## 85 HARRINGTON STREET, THE ROCKS - RESPONSE TO SUBMISSIONS

The below responses and further information are provided in relation to the response to submissions received by the applicant from the NSW Department of Planning for the project *85 Harrington Street, 66-68 and 80-72 Harrington Street, The Rocks (SSD 7037 MOD 2)*.

## **ADDENDUM TO HERITAGE IMPACT STATEMENT: 85 HARRINGTON STREET, THE ROCKS, NOVEMBER 2018**

Figure 6 – Bakers terrace previously approved and proposed basement plans

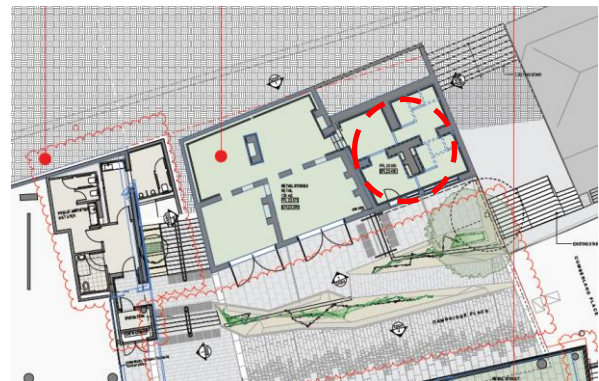
**1.0 Internal modifications to retain all internal walls** that are likely structural and represent the original layout that are currently enclosed behind a 1990s brick skin internal wall. It is assumed from the layout and the CMP that these concealed walls are original fabric. This modification is a requirement of the conditions of consent. This is a positive heritage impact. (FJMT drawing note reference L1(iii))

**2.0 Clarification on the original RLs to the basement.**

Further investigation has been completed to clarify the original RLs of the basement and are included in this design update. (FJMT drawing note reference L1(iii))

Figure 8 – Rear courtyard elevation showing sculptural element.

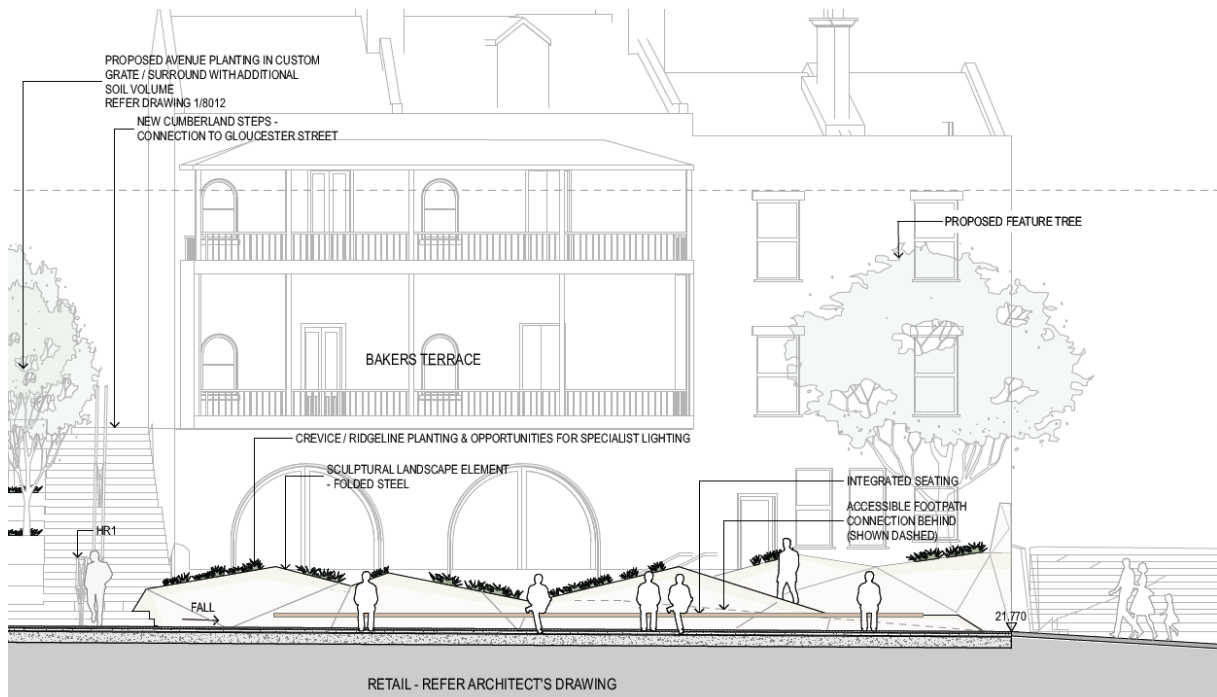
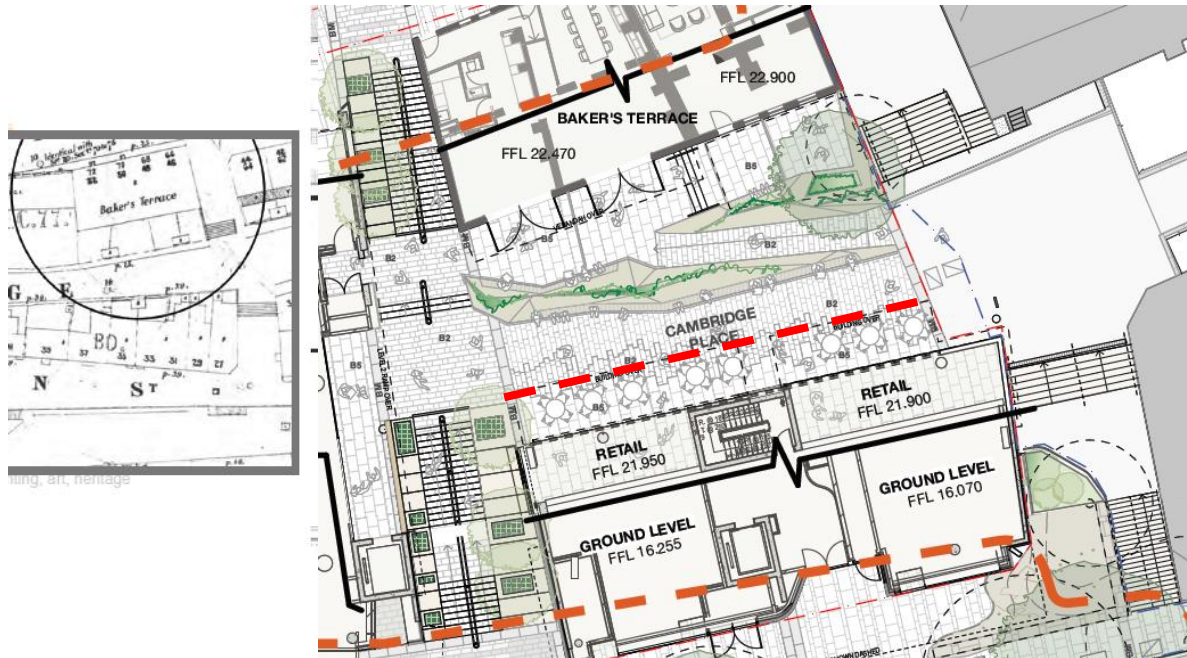
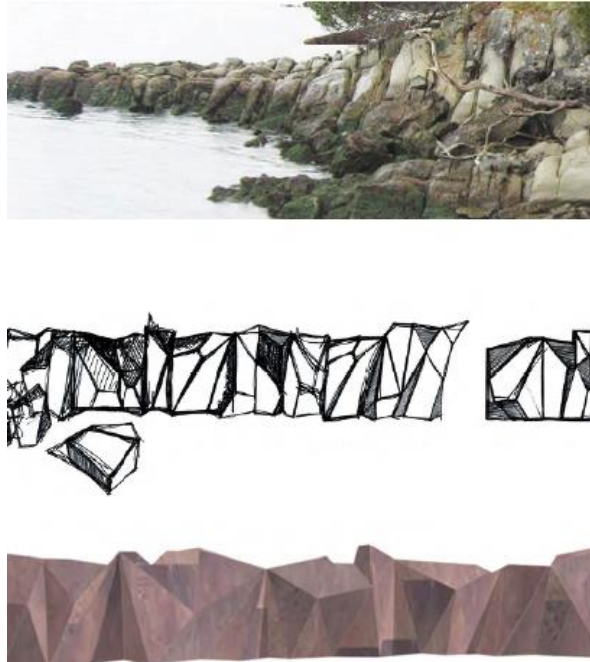
The landscape modification is a result of further design development and understanding of the complex level changes in this zone. The revised layout and levels is driven principally to provide a more integrated less intrusive equitable access to the basement and courtyard / laneway areas.

The major aesthetic change is the sculptural form that encases the access ramp and provides seating, planting and interpretation areas. This sculptural form has been designed in conjunction with artisans to provide a site-specific response to the courtyard that is contemporary. The design uses this regeneration opportunity to interpret the heritage context in a contemporary way in this highly public and unique space that is typical of The Rocks. The revised paving further defines the design to interpret the approximate location (exact locations to be confirmed) of the former Cumberland Place alignment.

Figure 12 – Bakers terrace previously approved and proposed ground floorplans

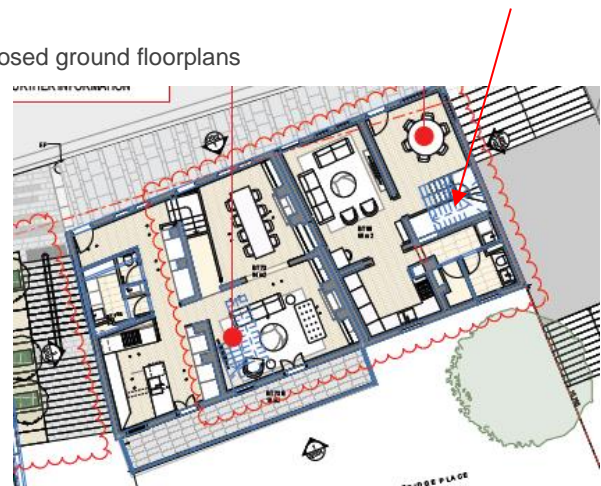
### 4.0 Internal stair to southern (right side) terraces relocated to front portion of the terrace.

The change of location of the stair presents no change or alteration to significant fabric and is proposed by the architects to achieve a more functional internal layout. This alteration has no effect on heritage significance and is therefore supported on heritage grounds.  
(FJMT drawing note reference L2(i))

### 5.0 Relocation of dining room and bathrooms. Relocated to satisfy conditions of consent and the request from PMNSW, Strategic Planning and Heritage Division. This relocation is a positive heritage outcome as the new dining room more closely reflects the larger room layout to the front of the terrace. (FJMT drawing note reference L2(i))

Figure 14 – Bakers terrace previously approved and proposed first floor plans

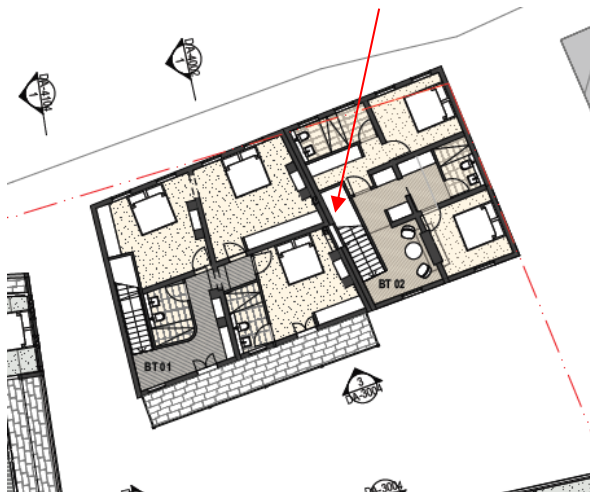
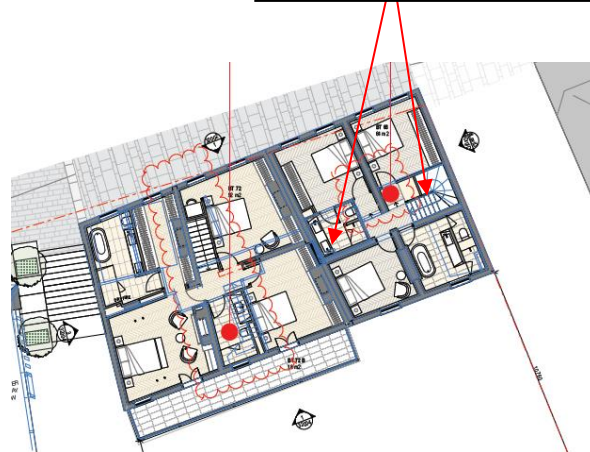
### **6.0 Relocation of the stair within the northern most terrace.**

This is to retain the section of wall identified on the CMP as original / exceptional significance. This stair relocation also involves the relocation of bathrooms to accommodate its new position. This relocation has a positive heritage outcome as it is more appropriate to not have a bathroom on the front façade and retain this as a habitable room and locate the bathroom in the new central position.

### **7.0 Split Level bedroom to first floor of 68-70 Gloucester Street**

Changes to the floor level to the norther pair of terraces (68) are proposed such that the FFL of level 1 is 29.650 to the two front bedrooms via a new floor frame on top of the existing structure. The front façade of the building is presented to the streetscape to match the windows aesthetically across the row of four. Due to this the site typography internal levels of the front bedrooms of the northern pair (to Gloucester St) have very high-level windows to bedrooms that are difficult to see out if and therefore provide reduced amenity to those rooms. This new level will involve the inclusion of two steps in the hallway to a new raised floor level to provide outlook from the bedroom windows. This new step and floor structure will sit on top of the existing as a new fame and will be completely reversible in the future if desired. Therefore, it is assessed that this element has no negative heritage impact from a heritage perspective. It enhances the amenity to make this a desirable space for residential occupation as per the original historic use.

Figure 17 – Proposed changes in plan to roof (area shown in red amendment bubble)

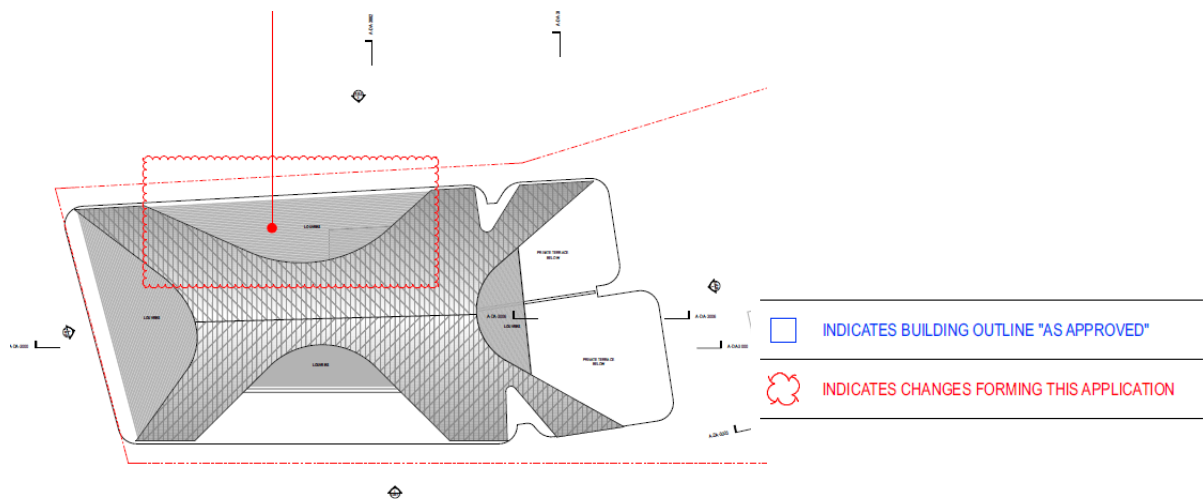
### 8.0 Additional louvred opening to roof on western side to provide ventilation for plant

The proposed changes to the roof do not alter the overall form, scale or presentation of a solid roof form and therefore have no change to the impact assessment on heritage grounds.

Figure 18 – Proposed changes in plan to new terraces fronting Gloucester Street

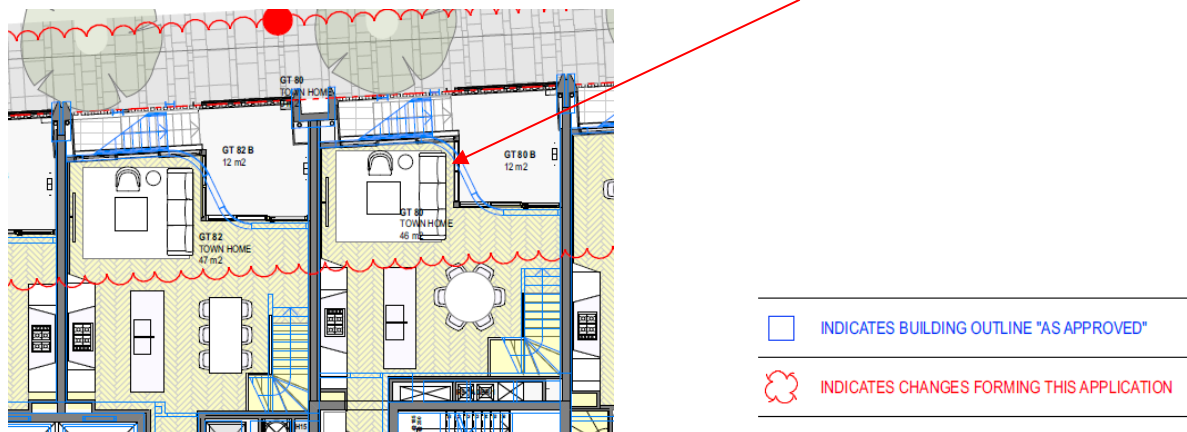
### 9.0 Minor alterations to terrace facade break up on Gloucester Street to provide greater design amenity to living rooms.

The proposed minor change to the plan layout to the living room of the new terraces do not change the overall form scale or presentation of the contemporary terrace form. Nor do they alter the resolved proportion and scaling of these architectural elements and their presentation and cohesion to the heritage streetscape.

Figure 20 – Harrington Street facades.

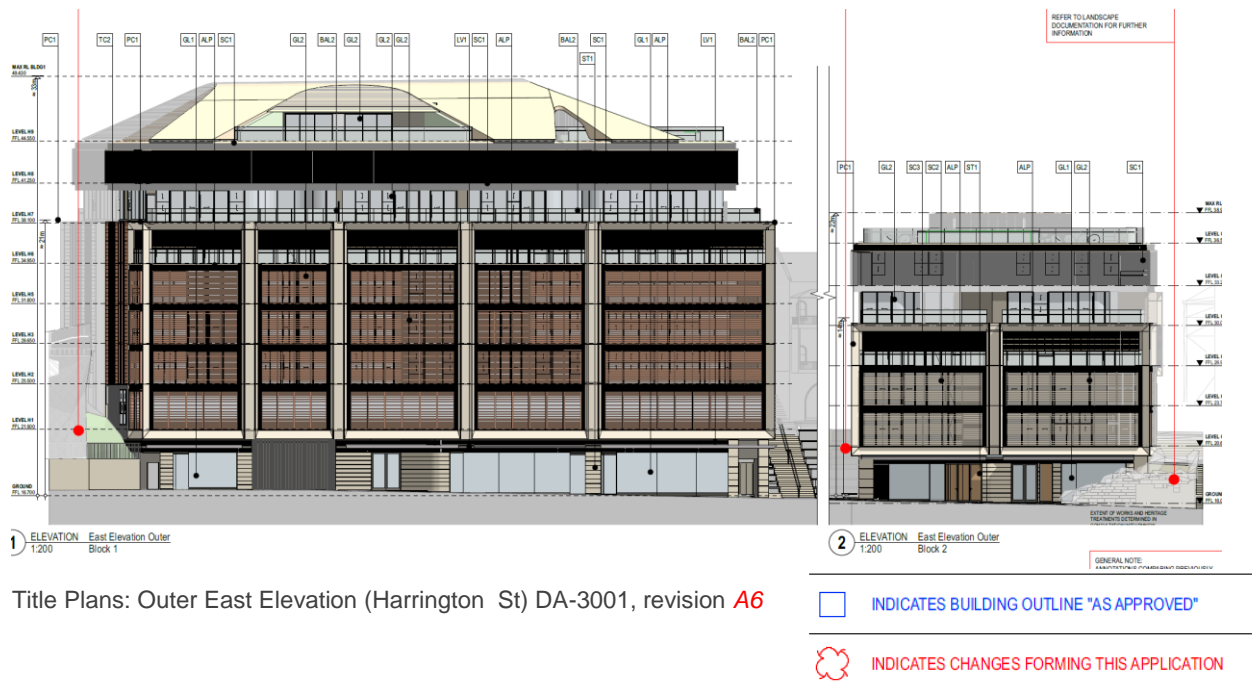
## 10.0 Minor alterations Harrington Street facades, and outer north

The changes are minor and related to internal planning and facade detail design layouts. They do not alter the design intent or architectural language response to the heritage context.

We also note the sandstone blockwork and bedrock to the northern corner at the stair junction is being retained in situ, the contemporary building wraps in behind.
